**Yarren Hut Solar Farm (SSD 10415)**

BCD has reviewed the biodiversity development assessment report (BDAR) for the project. BCD's biodiversity recommendations are provided in **Attachment A** and detailed comments are provided in **Attachment B**.

### Yarren Hut Solar Farm – Environmental Impact Statement

Figure 6-1 Final project layout

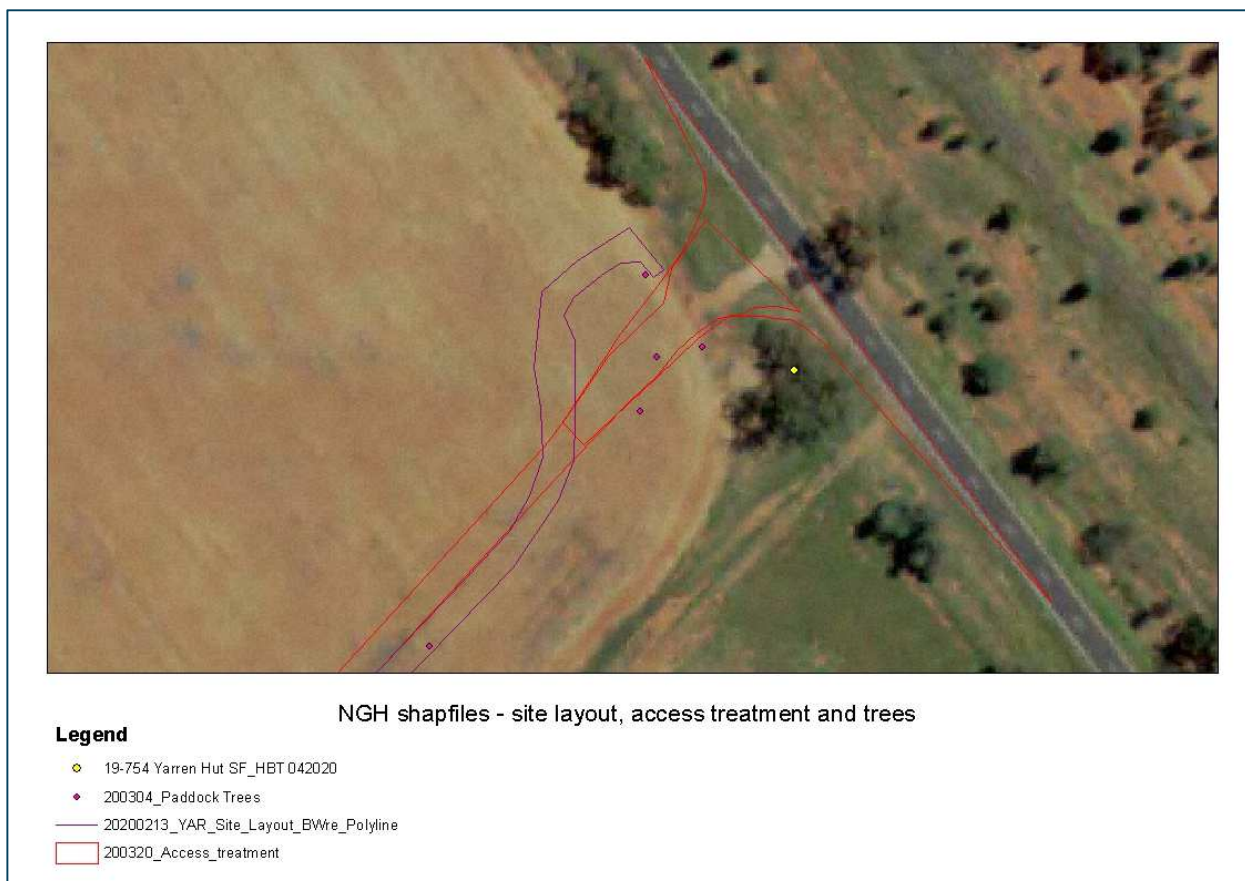
Two example maps (Figure 3-1 and 6-1) from the Biodiversity Development Assessment Report (BDAR) are provided below. They appear to show two different alignments for the access treatment. The alignment shown in Figure 6-1 appears to conflict with that shown in the remainder of the maps in the BDAR.

The map below shows the access treatment, site layout and recorded trees shapefiles provided to BCD by NGH. Despite checking the datum and projection of all layers, it appears there may be an issue in alignment of the files and the aerial image. Nevertheless, it appears the footprint shapefiles align with Figure 6-1 above but not the remainder of the maps in the BDAR.

Furthermore, it appears that the BAM plot established was located adjacent to, but outside of the development footprint. No plot data is provided from within the area of impact associated with the access treatment.

- a) a clear map at an appropriate scale which confirms the proposed location and extent of the footprint associated with the access treatment, correctly aligned with an aerial image. The polygon showing the footprint should be outlined only, with no shading.
- b) multiple photographs across the access treatment footprint to confirm the nature of the vegetation and structural elements in that area.
